TO: City of Gainesville
Development Review Board

Item Number: 1

DATE: December 22, 2015

SUBJECT: Petition DB-15-52 SUB. Fetner Engineering (Alison Fetner) agent for Gainesville Cohousing LLC, owner. Design Plat review for a Cluster Subdivision. Zoned: RSF-4 (8 units/acre single-family residential district). Located at 4751 NW 27th Avenue.

**Map 2.
Cluster Subdivision Lot Layout**

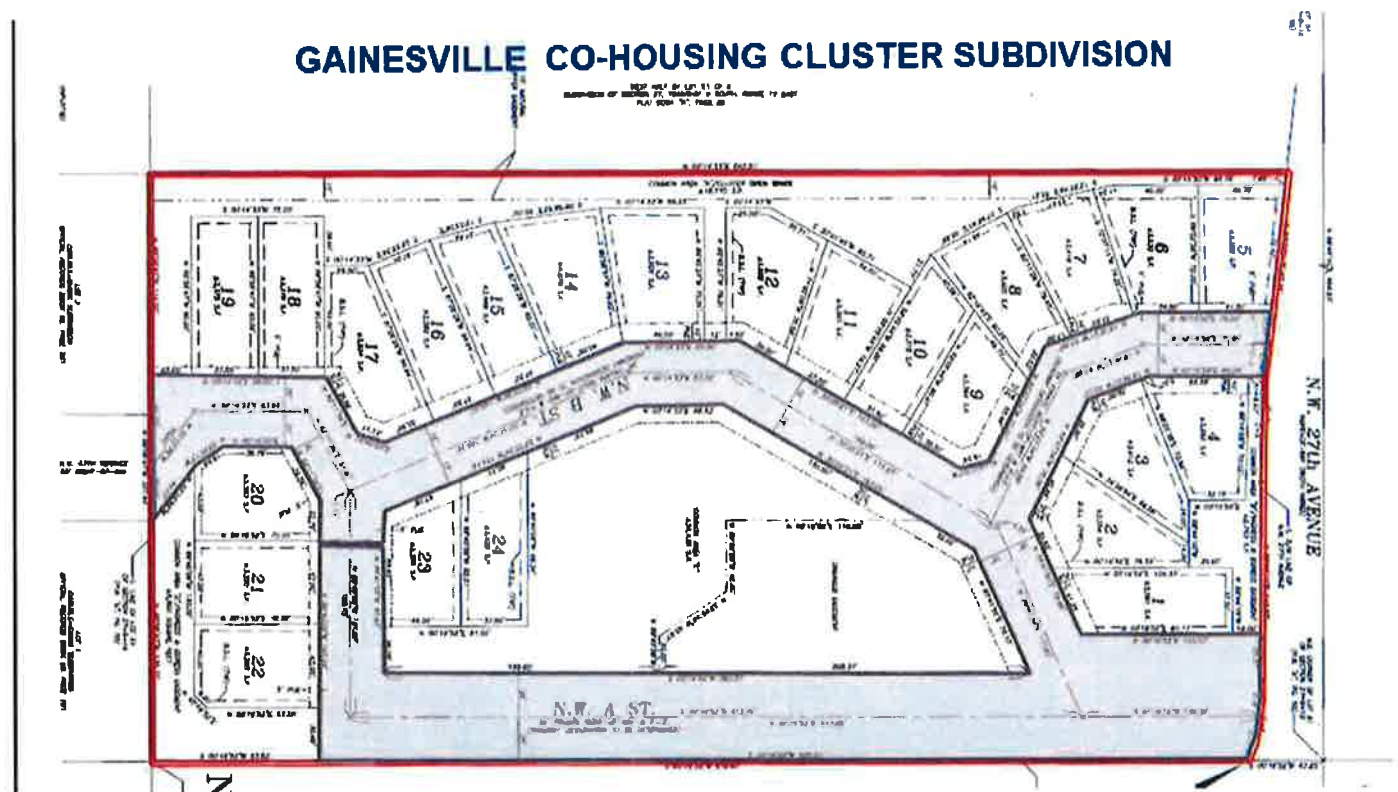
The proposed subdivision is requesting modifications to the above standards. The size of lots is reduced to below the 4,300 square feet allowed in the RSF-4 district; lot sizes range from 3,265 to 4,079 square feet. This modification is also allowed under the Cluster Subdivision design provided that no lot is less than 75% of the required lot size.

Lot widths and depths are modified to below the 50 foot and 90 foot respectively; lot width varies between 34 and 47 feet and lot depth ranges from 72 to 103 feet.

With reference to the west boundary of the subdivision, a portion of the adjacent property is improved and zoned RSF-4 requiring setbacks equivalent to the RSF-4 standards for lots 5, 6 and 7. This requirement is modified since the lots are not actually abutting the adjacent RSF-4. Staff has some minor concerns but considering the limited extent of the condition and the actual code language; staff recommends the setbacks as presented.

SHEET TITLE:
**DESIGN PLAT
 PLAN REVIEW
 GENERAL LANDSCAPE PLAN**

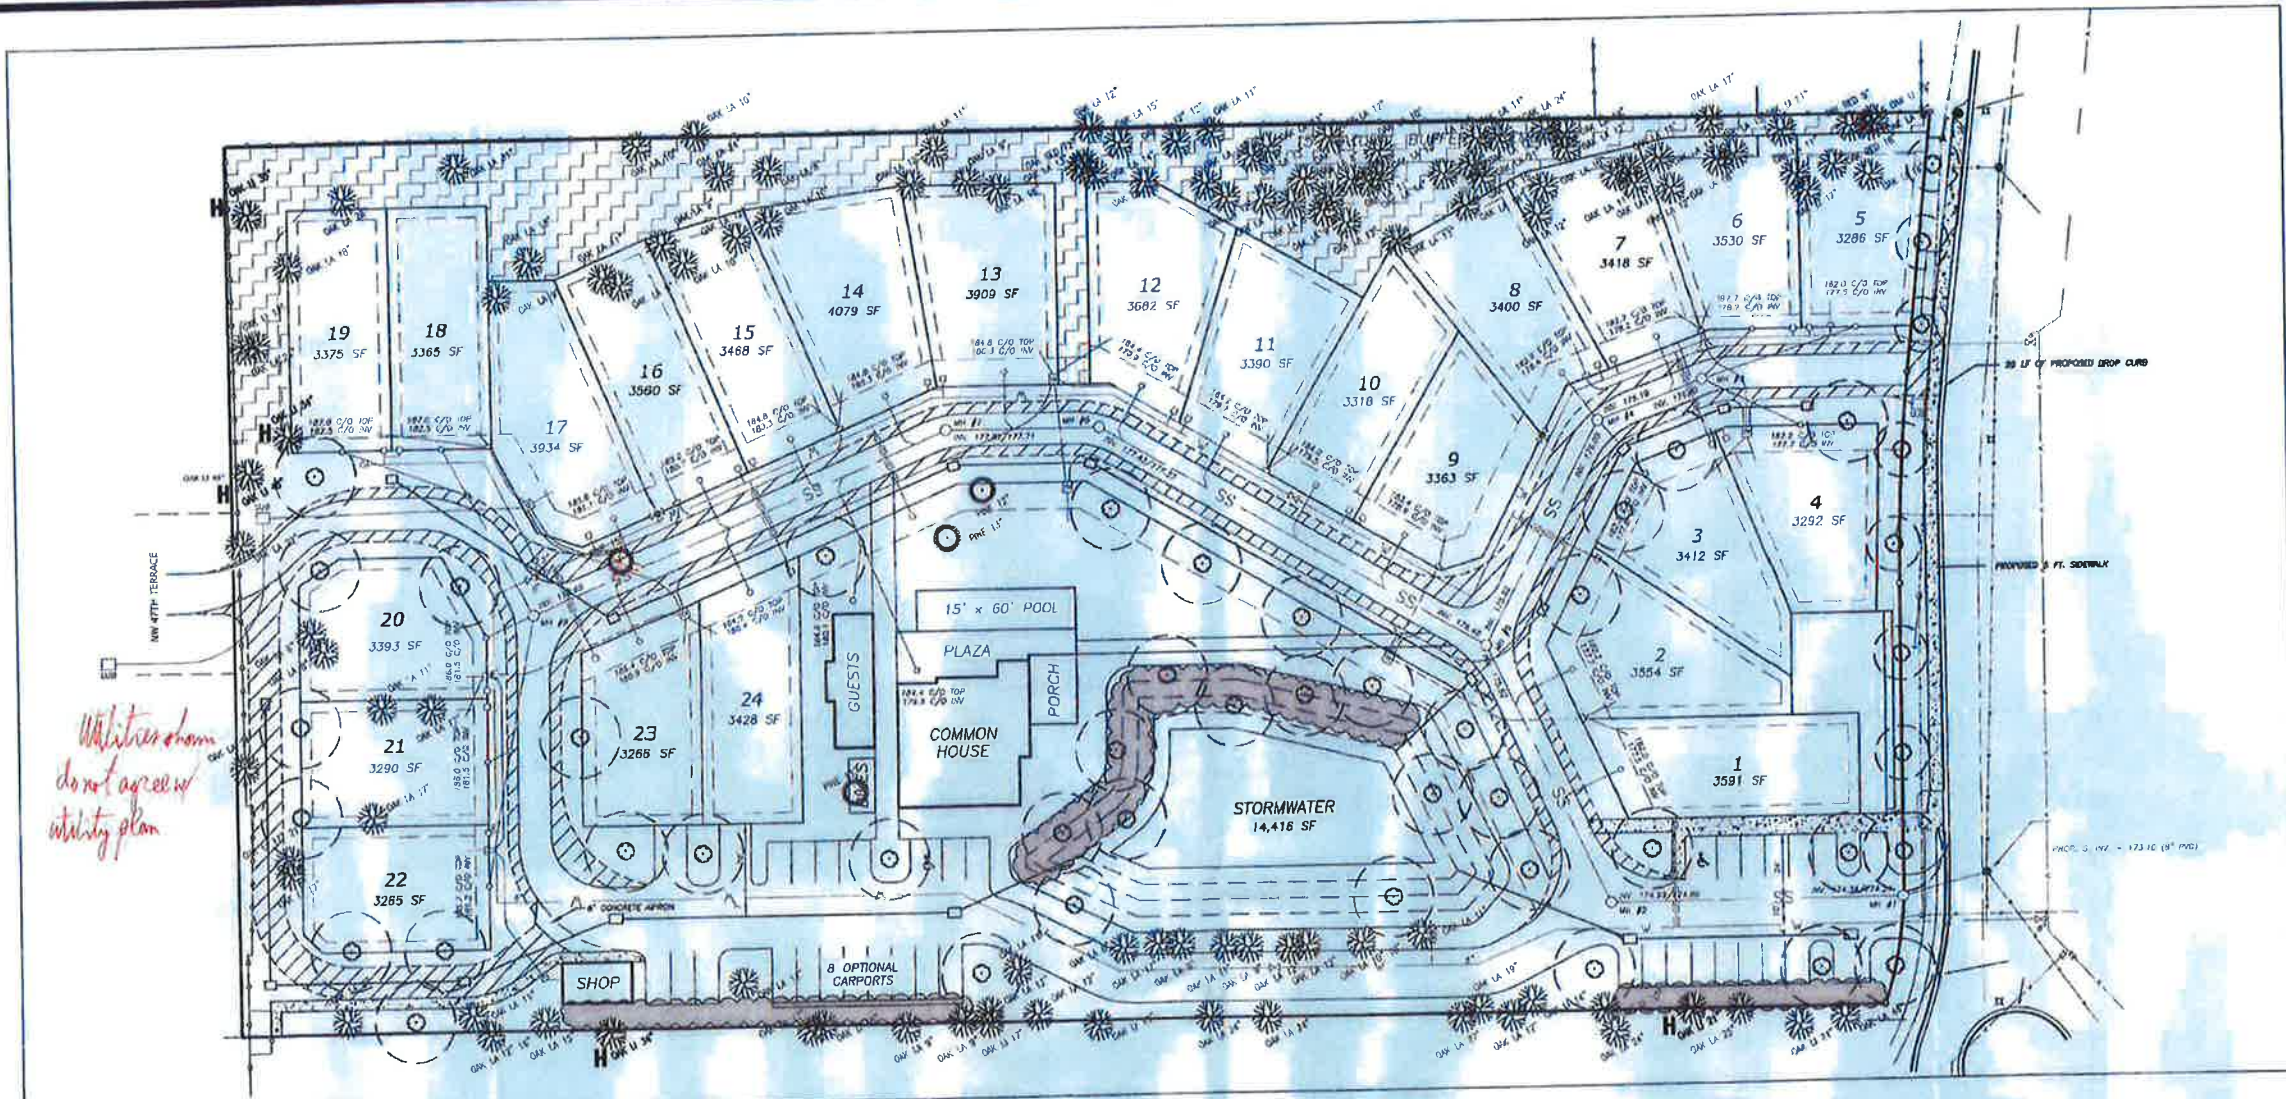
13. Street trees along the north side of "B" Street are not provided to facilitate placement of solar equipment on the adjacent houses. The required trees are placed elsewhere to compensate for trees not placed within the right-of-way. An alternate plan shall be presented during Construction Plan Review.

During Construction Drawing review, a landscape plan shall be proposed to provide suitable landscaping along the north side of the internal roadway.
